PROPOSED AMENDMENT TO REGULATION No. 117

Transmitted on behalf of the GRRF Ad-Hoc tyre wet grip group

"UNIFORM PROVISIONS CONCERNING THE APPROVAL OF TYRES WITH REGARD TO ROLLING SOUND EMISSIONS AND TO ADHESION ON WET SURFACES"

Annex 2 example 2 modify to read:

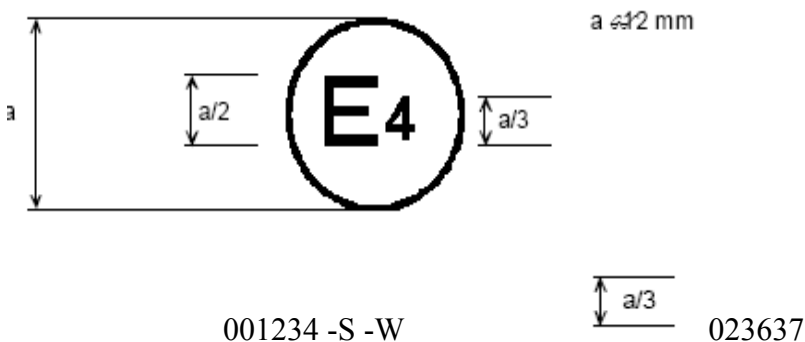
The above approval mark, affixed to a pneumatic tyre shows that the tyre concerned has been approved in the Netherlands (E4) pursuant to Regulations No. 117 (marked by "-S" [and] [or] "-W") and Regulation No. 30. The first two digits of the approval number indicate that, at the dates when the respective approval was granted, Regulation 117 was still in its original form, but No. 30 included the 02 series of amendments.
